ISO/IEC JTC 1/SC 25/WG 3 N 754

DOC TYPE: Liaison document
TITLE: Letter to the chairman of IEEE 802.3 on a WD for ISO/IEC TR 24750: Guidelines for the support of 10GBASE-T over Copper Balanced Pairs of Class E and Class F as per ISO/IEC 11801(ED.2.0): 2002 and IEEE 802.3an
SOURCE: WG 3 Secretariat
PROJECT: 25.03.02.02-03
STATUS: SC 25/WG 3 N 746 has been distributed for internal review by the WG 2005-03-16, the comments, collated in SC 25/WG 3 N 752, just came in and the resolution process will start in few days. It will include comments from IEEE 802.3 in case such are provided.
ACTION ID: FYI
DUE DATE: n/a
REQUESTED ACTION: For information
The attached drafts are forwarded to IEEE 802.3 as preliminary information, for consideration and if wished for comment.
MEDIUM: Def
No of Pages: 63 (including cover)

**Letter to the chairman of IEEE 802.3 on a WD for ISO/IEC TR 24750:
Guidelines for the support of 10GBASE-T over Copper Balanced Pairs of
Class E and Class F as per ISO/IEC 11801(ED.2.0): 2002 and IEEE 802.3an**

DOC TYPE: Working draft
TITLE: WD for ISO/IEC TR 24750: Guidelines for the support of 10GBASE-T over Copper Balanced Pairs of Class E and Class F as per ISO/IEC 11801(

190 **Figure 1 – Example of short channel and long Channel disturbing each other**

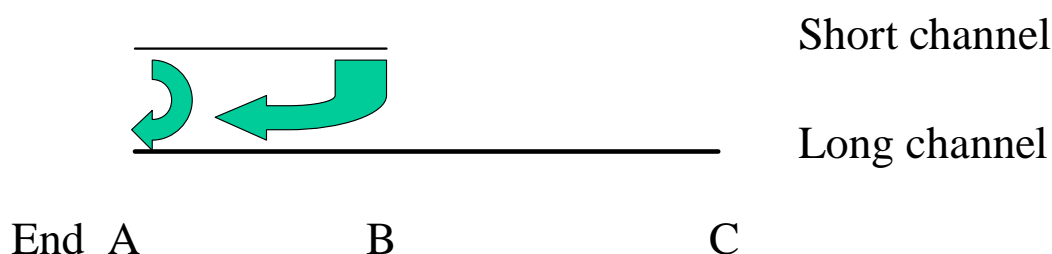
Page	Line	Clause	E/G/ T	ID	Comment	Proposed change	Observation of the Secretary
08	171	5	T	SYS-5	Crosstalk is noise within the same channel while alien crosstalk is noise coming from outside the victim channel.	Change: Alien crosstalk and power sum crosstalk are well defined in ISO/IEC 11801(ED.2.0): 2002 and relate to noise coming from the other pairs in the same channel. To: Crosstalk and power sum crosstalk are well defined in ISO/IEC 11801(ED.2.0): 2002 and relate to noise coming from the other pairs in the same channel.	Accept, see UK06
08	171	5	T	vPty3	Up to now alien crosstalk is not specified	Change: alien crosstalk and power sum, to: crosstalk and power sum	Accept, see UK06
08	177	5	T	UK07	Also well known for all existing versions of twisted pair Ethernet	Combine with previous para and replace "10BASE-T" with "existing versions of Ethernet over balanced cabling".	
08	182	5	E	UK08	Reference to 802.3an D1.2 is not necessary; the statement does not require qualification.	Delete reference.

08	184	5	E	UK09	Spelling of "were"	Change to "where"	
08	184	5	E	IL4	Line 184: Misspelling	Change "were" to "where"	
08	188	5	E	UK10	Why is there a reference to ISO/IEC SC25 WG3?	Delete reference or elaborate as an editor's note.	
08	189	5	E	LCG-4	In the Figure 1, need to define the size of the text		
08	194	5	E	UK11	The NOTE is not necessary. PSAELFEXT limits are proposed by 802.3an D2.0 (see AVF15).	Delete NOTE.	
08	194	5	E	IL5	Line 194: SEE IL1	Delete note as DRAFT 2.0 contains the formulae	
09	195	6	T	UK12	195 – 392 Whilst it is the Channel that supports the application, the Channel may not always be in place (even on cabling that has already been installed). It may only be possible to test a Permanent Link. As in the current ISO/IEC 11801:2002, we should the option to "conform" against Permanent Link "requirements". This will also maintain harmonisation with the current TIA TSB-155 draft document.	Include Permanent Link" requirements" for all parameters. Use the information contained in 3N731 (or a later contribution if available) as a starting point.
